MONITORING YEAR 6 ANNUAL REPORT

VILE CREEK MITIGATION SITE

Alleghany County, NC
DEQ Contract No. 5999
DMS Project No. 96582

RE: Response to Monitoring Year 6 (MY06) Report – Draft Submittal Comments
Vile Creek Mitigation Site
DMS Project # 96582
Contract Number 5999
New River Basin - HUC# 05050001 - Alleghany County, North Carolina

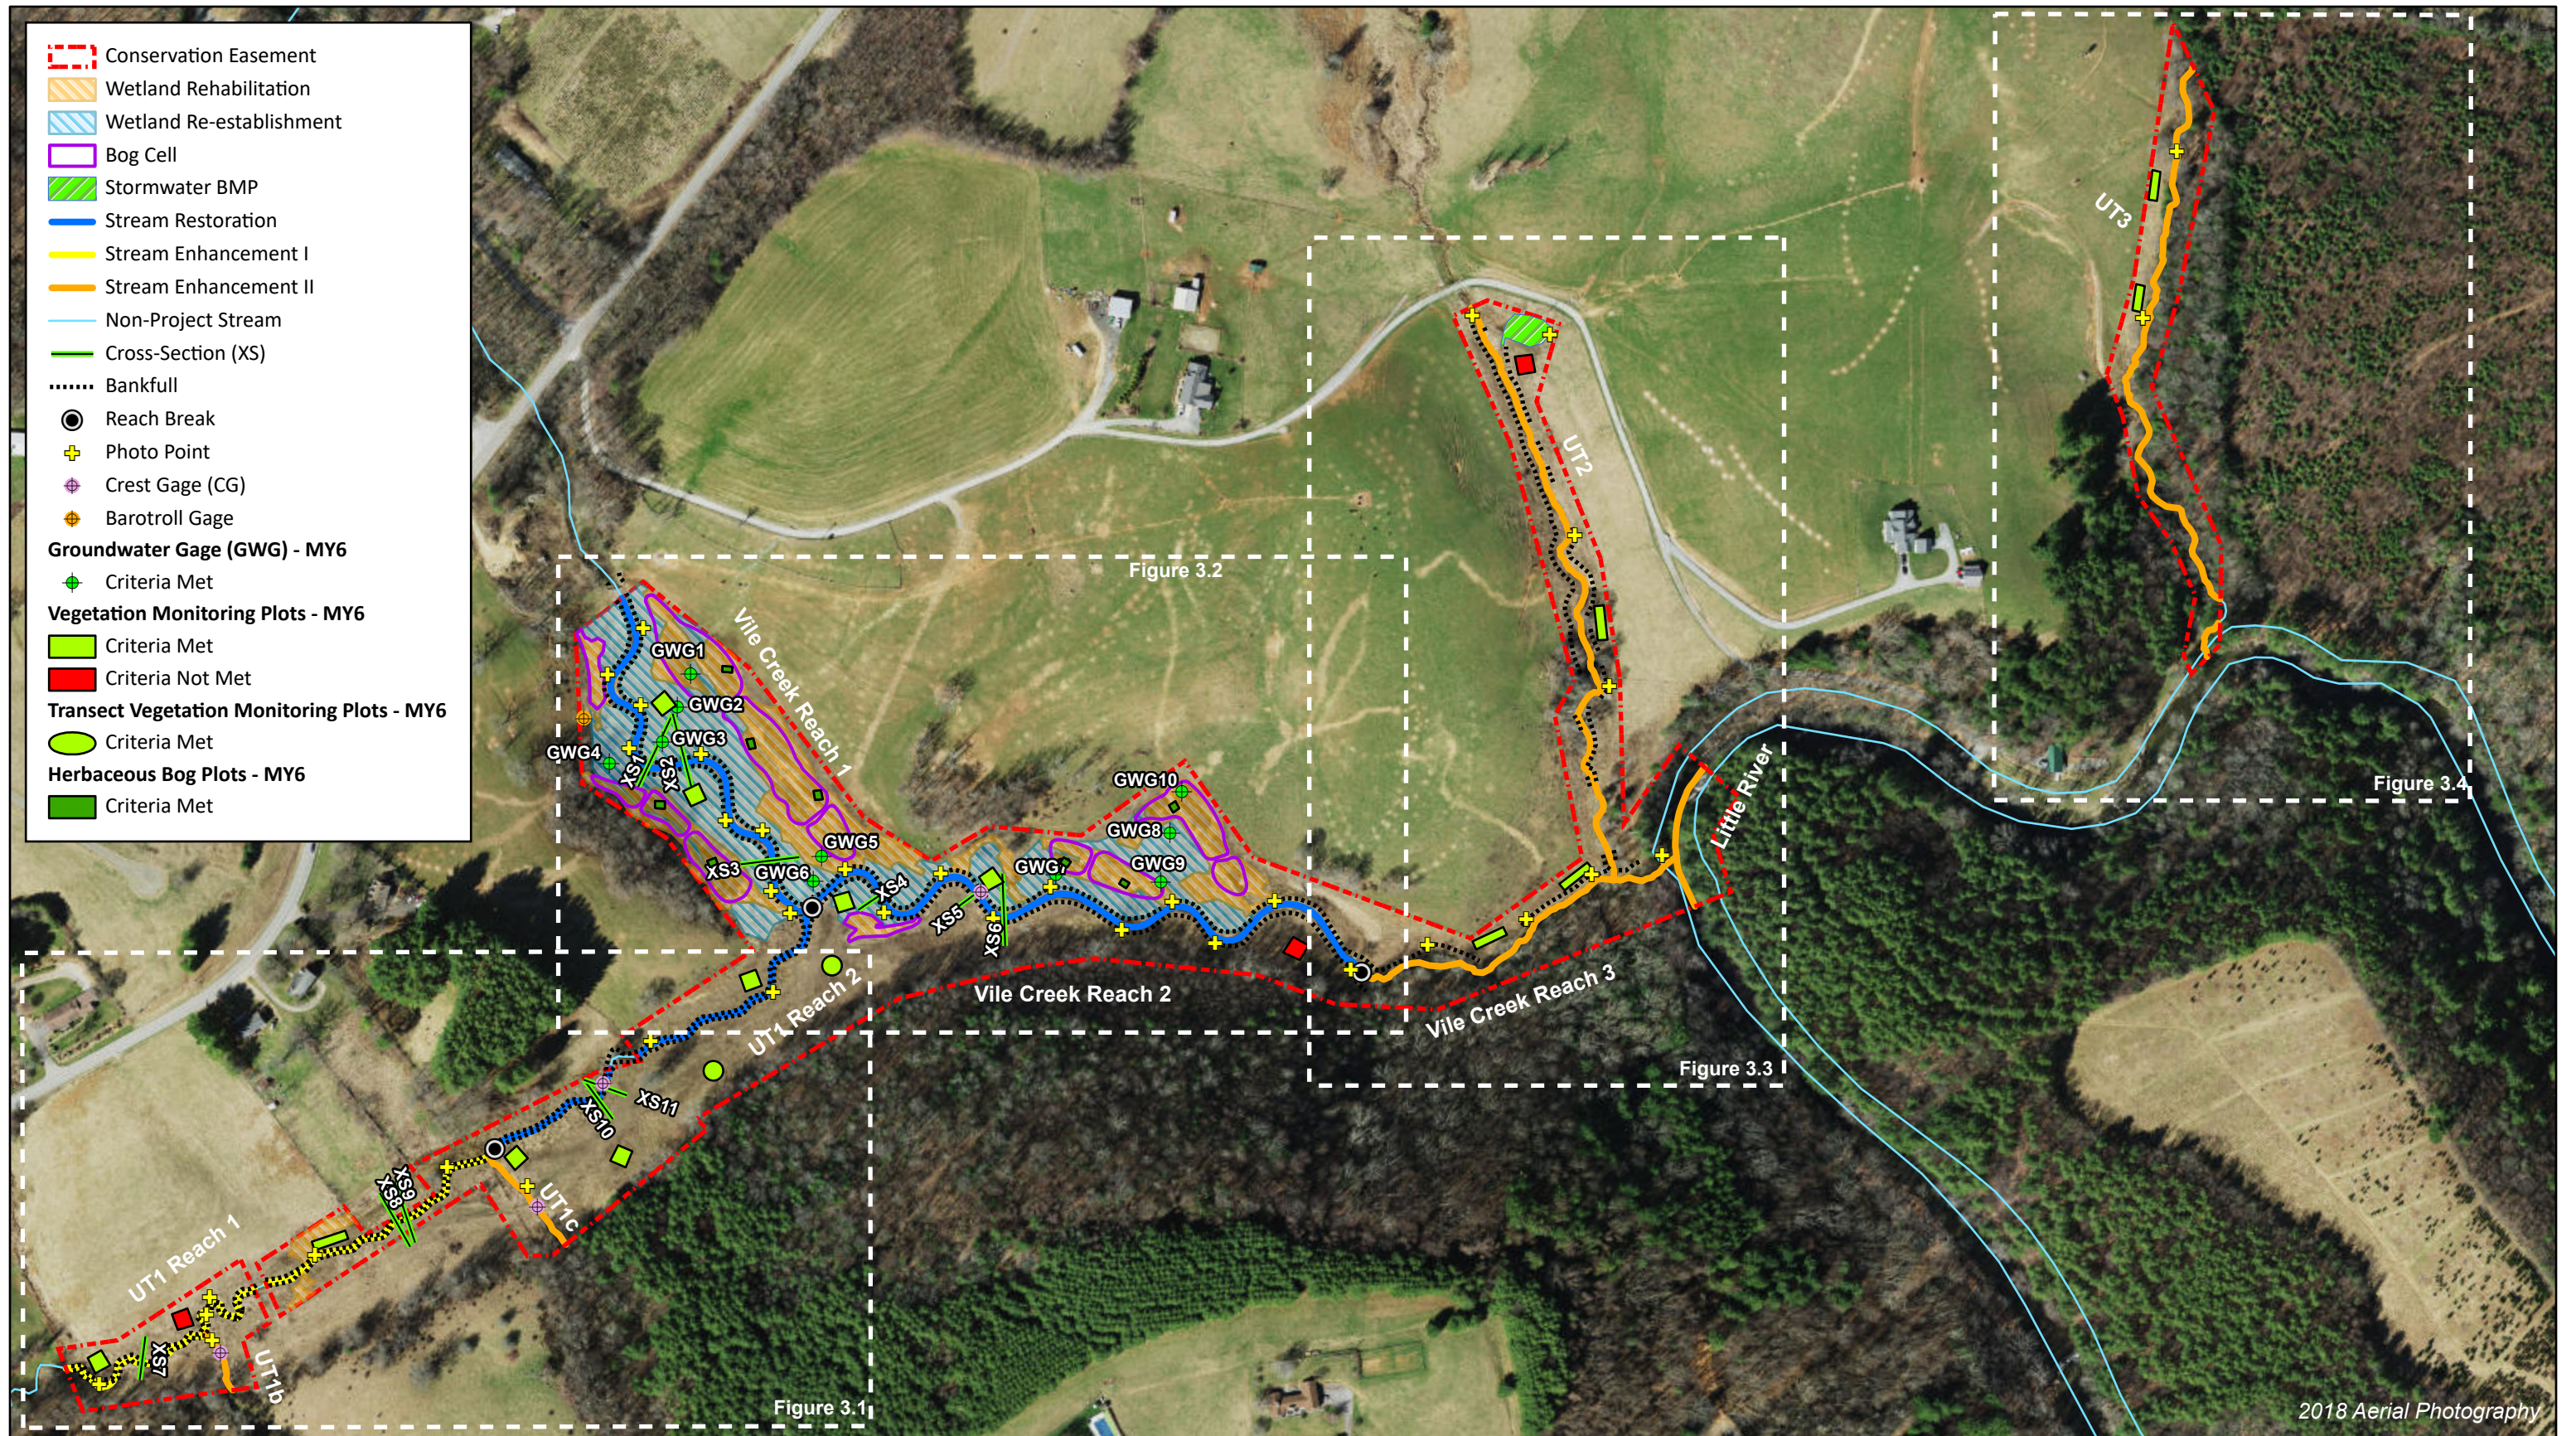
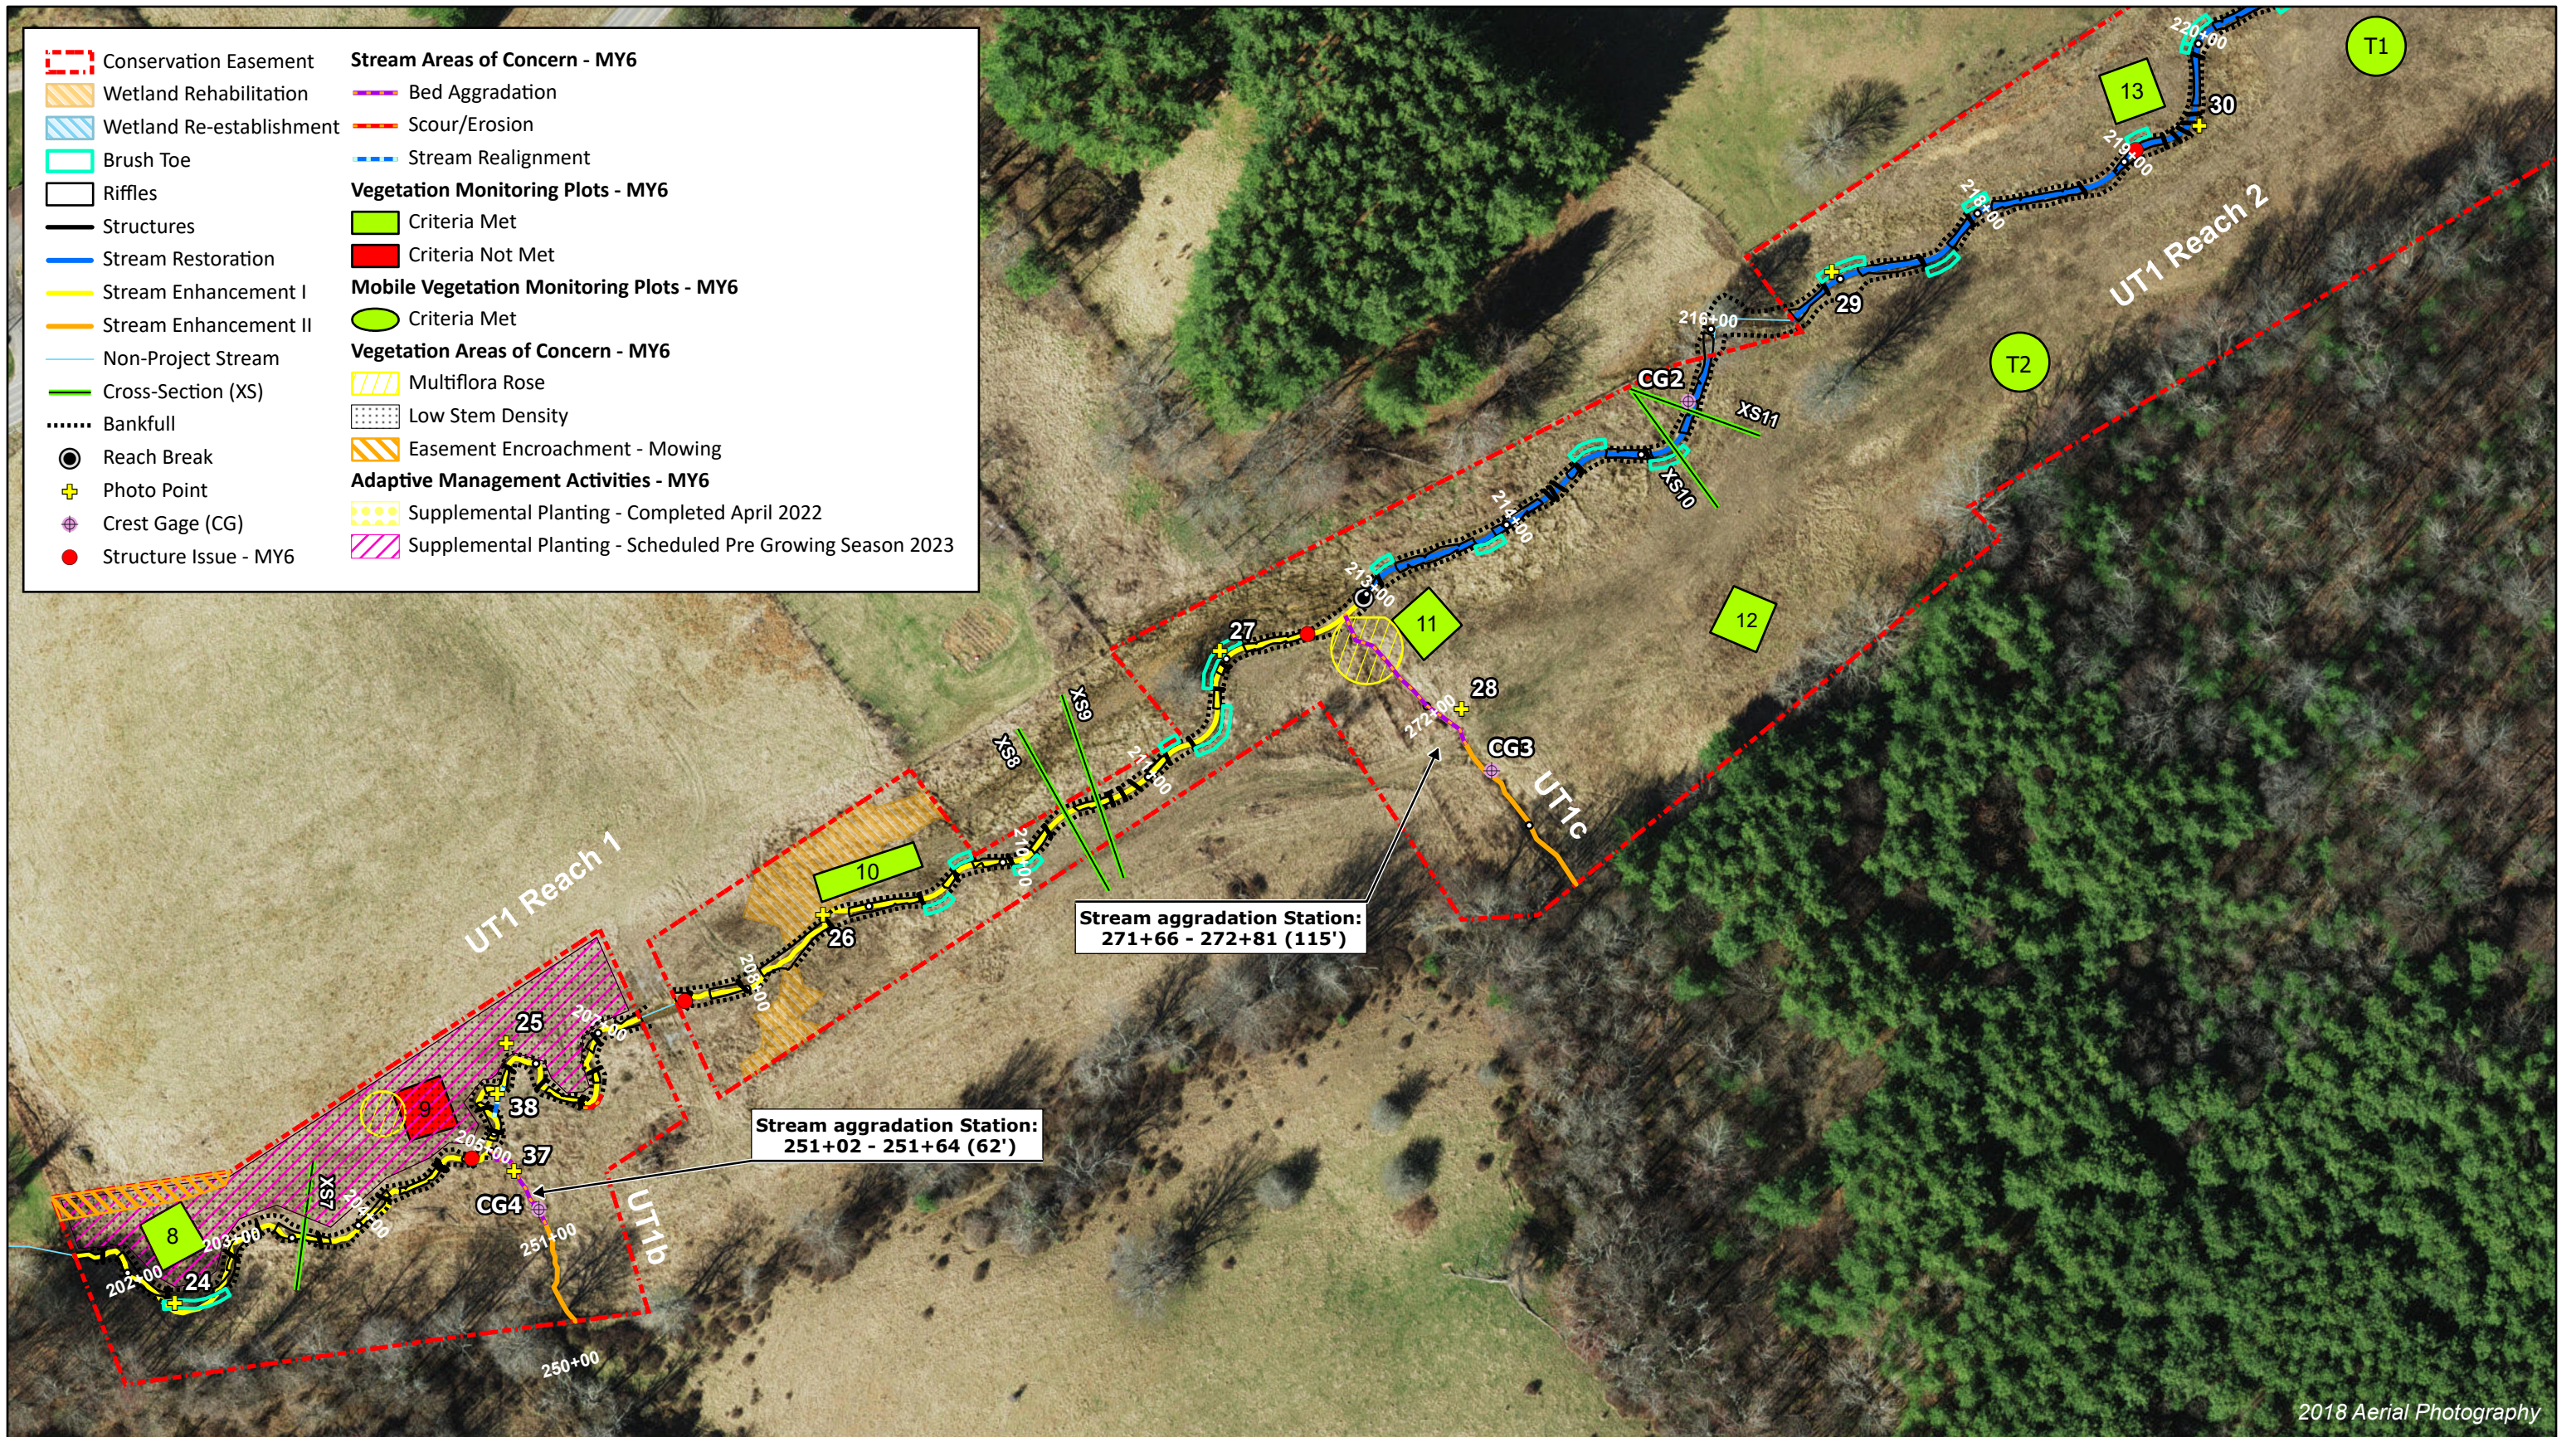
At the 2022 credit release IRT meeting, WEI noted that UT2 will be supplementally planted in the future. The CCPV did not reflect any supplementally planting along UT2. Please advise or clarify.

Wildlands Response: Additional supplemental planting will occur before the onset of the 2023 growing season in low stem density areas on Site (approximately 1 acre) including an area along the left bank of UT1, and upstream sections of UT2. The areas will be replanted with one, three, and/or five-gallon containerized trees. Species will include those approved in the Vile Creek Mitigation Site Final Mitigation Plan and 2021 Vile Creek Mitigation Site Adaptive Management Plan (Wildlands 2016, 2021). The planted species, sizes, wetland indicator status, and quantities will be documented in the MY7 monitoring report. Refer to CCPV Figures 3.1 and 3.3 in Appendix 2 and Section 1.2.5 for supplemental planting locations and low stem density acreages.
